Architectural Review Board Report

Architectural Review Board Meeting: February 3, 2014

Subject: ARB 13-451 to approve the design, colors, and materials for the construction of a mixed-use project consisting of 377 residential rental units and up to 24,940 square feet of ground floor neighborhood-serving retail of which up to 4,250 square feet could be converted to production space.

Address: 2930 Colorado Avenue
Applicant: Village Trailer Park LLC

Figure 10: View of paseo between Building A and B demonstrating additional skyline variation and increased building articulation

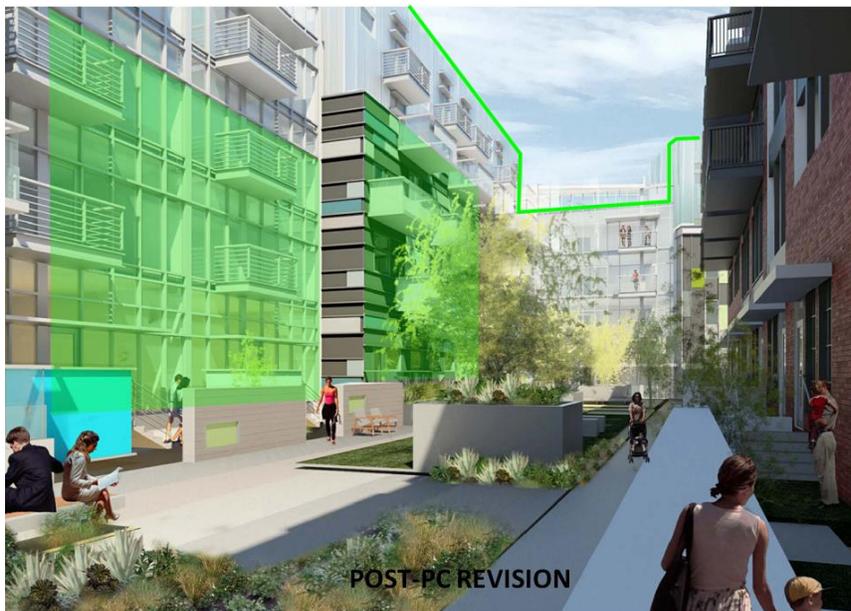
a. Staff has concerns that the number of design elements, sizing, and shapes create very busy elevations on the first 3 levels. It is not clear how the building transitions between the horizontal elements of the lower levels to the vertical elements on the 4th and 5th floors.

b. While the ground floor features are successful in creating pedestrianscale amenities (e.g. awnings, seating areas, storefronts), the middle section of the building immediately above is not as successful in achieving a human-scale. The strong horizontal shapes work to emphasize the size and scale of the building.

The building design has significant stepbacks (3-6ft) and returns where the building transitions between different patterns and materials. These massing concerns had been discussed and addressed with the Planning Commission.

In the context of an integrated discussion of the design concept of the building as a whole, the applicant welcomes feedback from the Board on this issue. The build-up diagram on Sheet B322 explains our approach to adding motion and movement to an otherwise regularly patterned façade.

We believe that the residential balconies and residential window sizes at the middle sections do give this portion of the building a human scale, while not

interfering with the overall concept of the façade, as a whole. The composition of these smaller-scaled elements, work together to reinforce the overall design concept.
